Number	Description
1	Revised Table of Contents; Add SP No. 907-413-5; Revised Bid Items; Amendment EBS Download Required.

**PROJECT: MP-2082-00(076)/305457301 - Carroll
MP-2082-00(076)/305457302 - Montgomery**

| SPECIAL PROVISION NO. 907-413-5

SUBJECT: Sawing and Sealing Transverse Joints in Asphalt Pavement

DETAIL OF SAWING AND SEALING TRANSVERSE JOINTS

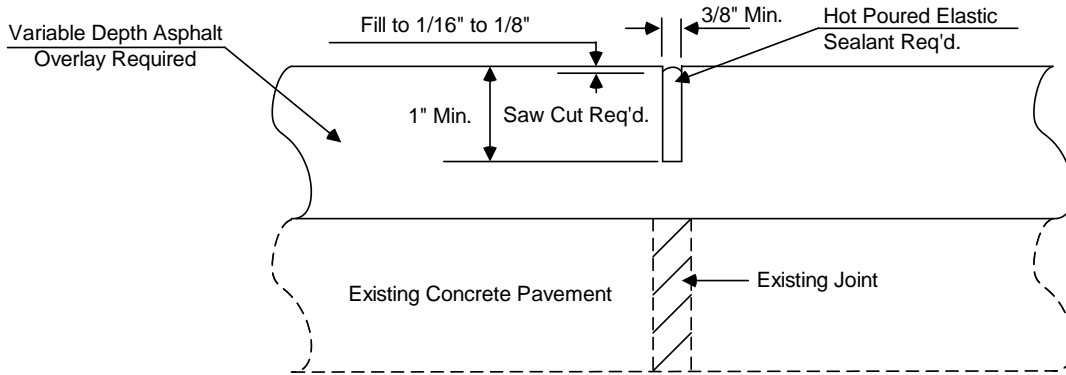
907-413.03.3.1--General. Delete the first paragraph of Subsection 413.03.3.1 on page 296 and substitute the following.

The Contractor's operation shall be conducted so that sawcutting of transverse joints, cleaning, and sealing is a continuous operation. The entire sawing and sealing operation shall be completed within seven (7) days after the placement of the final wearing course, unless the approved traffic control plan or sequence of operations provide otherwise. Traffic shall not be allowed on sawed unsealed joints in the final wearing course.

When intermediate lifts must be exposed to traffic for over seven (7) days, the Contractor shall be required to make an interim 1/8-inch wide saw cut which is one third (1/3) as deep as the asphalt layer. This interim saw cut does not require sealing. Costs of any interim cut(s) shall be included in the pay item for sawing and sealing transverse joints in asphalt pavement.

The detail for sawing and sealing transverse joints in asphalt pavement shall be as shown below. No sawing and sealing of transverse joints will be required in Open Graded Friction Courses (OGFC). However, the lift under the OGFC will require sawing and sealing.
